NORFOLK BOREAS OFFSHORE WIND FARM

Planning Inspectorate Reference: EN010087

Updated Ornithology Advice

Natural England's comments in relation to the Norfolk Boreas updated offshore ornithological assessment, submitted at Deadline 2 [REP2-035]

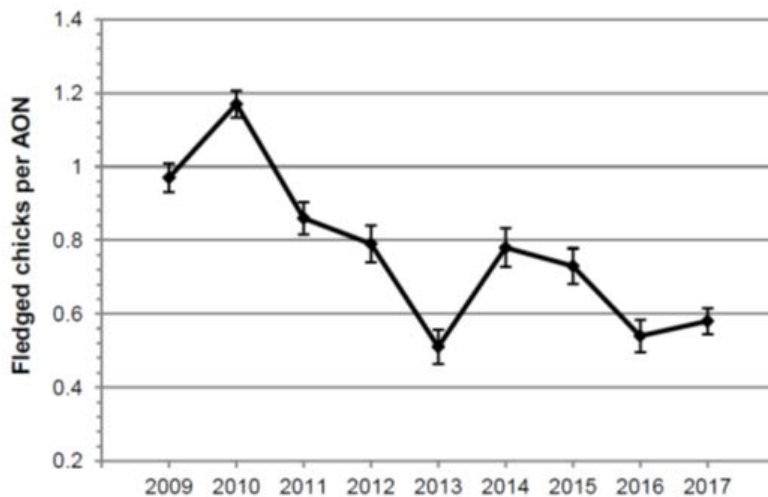
There is no evidence to suggest that the future population trend will be significantly different from the current trend of 0.37% per annum (2000-2017), for example productivity at the colony has not been increasing in recent years (see Figure 1). (Aitken et al. 2017). So, based on the review of growth rates above, it seems reasonable to assume that the FFC SPA colony growth rate will be <1% per annum.

Therefore, as this feature has a restore conservation objective, and because there are indications that the predicted level of mortality would mean the population could decline from current levels should it currently be stable, **it is not possible to rule out AEOL of the kittiwake feature of the FFC SPA for collision impacts from in-combination with other plans and projects, both including and excluding Hornsea 3 and Hornsea 4.**
